Appendix 2: Right of Reply – summary of hearing discussion, response points, and revised recommendation(s):

This table contains the recommendations for sites not provided to the Panel on Tuesday 6th September. This consists of the following sites:

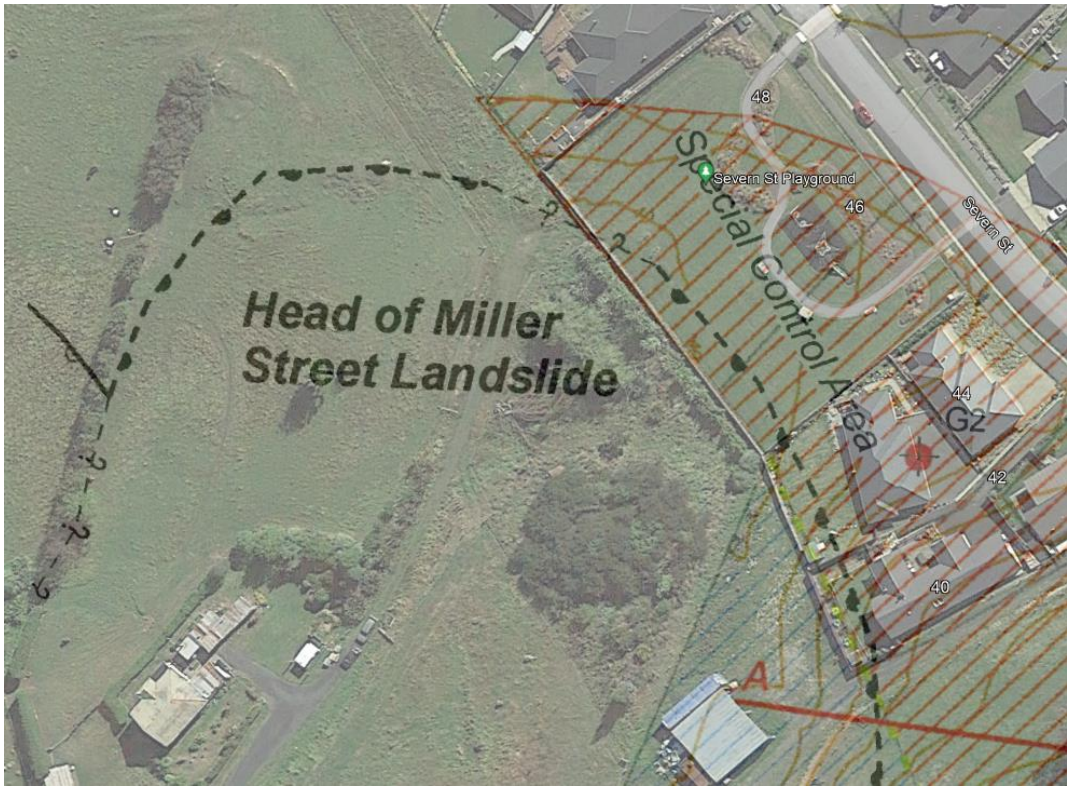
1. In Appendix 1 of the right of reply, given to the Panel on Tuesday 6th September, my recommendation for this site was to rezone GF05 (subject to an NDMA and a structure plan), and to not rezone GF05a (due to geotechnical concerns).
2. During the presentation from Mr Lee Patterson from Stantec, there was some discussion about the appropriateness of a road being constructed across the head of the Miller Street landslide. The proposed link road connecting Severn St with Main South Road would appear to have to pass over this area. 10m offset is recommended from this area for buildings, and a map of this is shown below:

3. If road construction was found to be too risky, there appears to be no other possible secondary connection point within the area of GF05. The primary connection would be from Main South Road.

5. In light of this, I wish to amend my recommendation for GF05 slightly. I still recommend rezoning GF05 to General Residential 1, however I wish to amend my structure plan recommendations to require, rather than "provision of a connecting road", provision of a pedestrian/cycling connection between Severn St and Main South Road and also an information requirement for the developer to investigate a secondary access point at the time of subdivision. In all other respects, my recommendation remains unchanged.

Figure 15.8.AAA: Honeystone Street structure plan

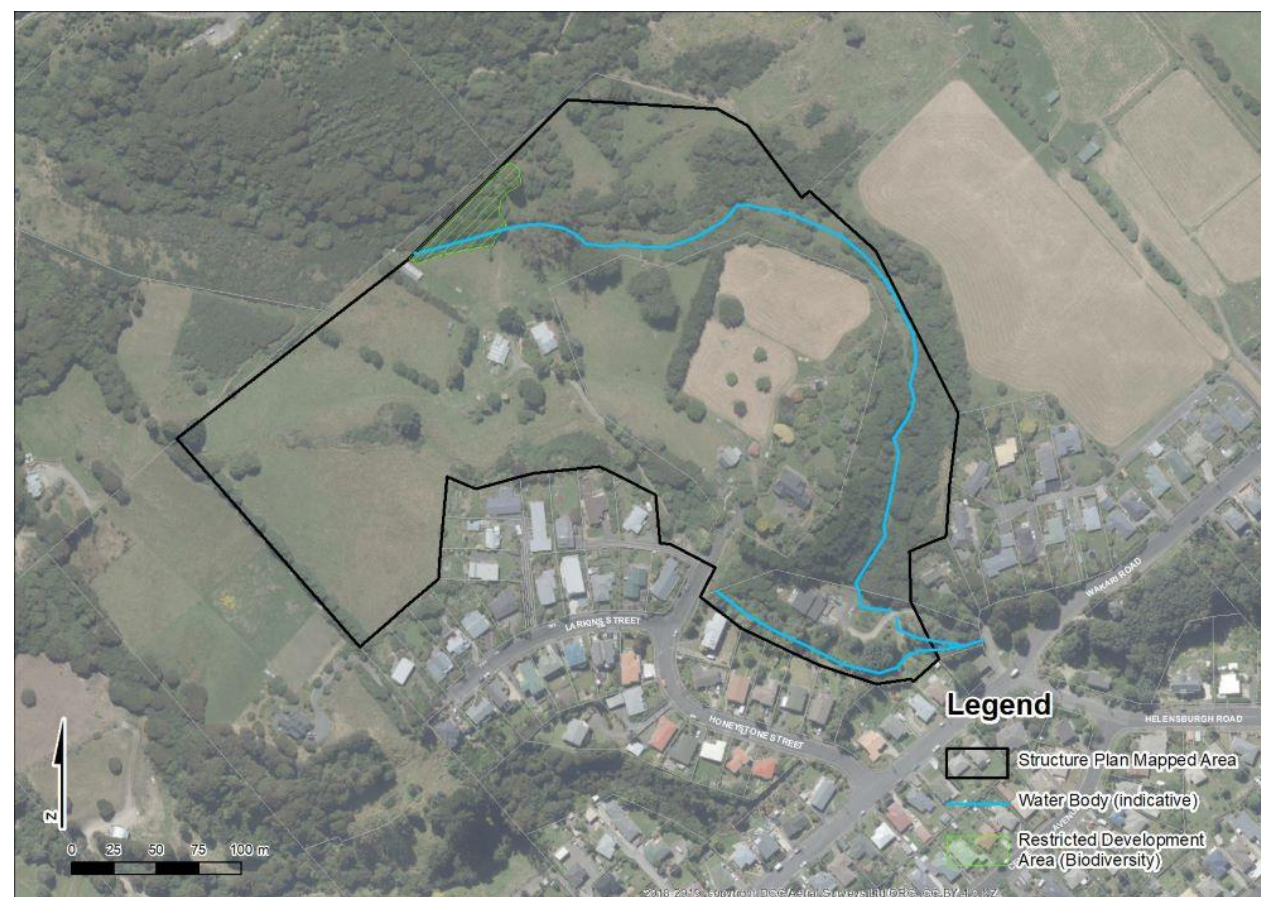
7. As a result of my recommendation on GF11, as discussed above, there is potential that a roading connection from GF11 through to Honeystone St may be necessary, if the developer is unable to achieve the currently proposed access to Wakari Rd via 195 Wakari Rd.

8. Should a connection to Honeystone St be required, it is necessary to amend the proposed Honeystone Street Structure Plan Mapped Area Performance Standards (Rule 15.8.AA). This is because the current structure plan rule only permits a single crossing point through the water body that lies within GF10. If a connection with GF11 were required, two crossing points would become necessary (one to access GF11, the other to access the northern area of GF10).

9. I therefore maintain my recommendation for GF10, but recommend the structure plan wording is amended as follows to allow for a second crossing point into GF11 if required:

- a. Vegetation clearance must not occur within 5m of the water body that is identified on the Honeystone Street structure plan and labelled 'Water Body' (see Figure 15.8.AAA), except for:
 - i. the construction of a crossing point for a single accessway to the part of the structure plan mapped area that is on the northern side of the water body; or
 - ii. if a connection to the adjacent Helensburgh Structure Plan Mapped Area is required, construction of a crossing point for a road into the Helensburgh Structure Plan Mapped Area.
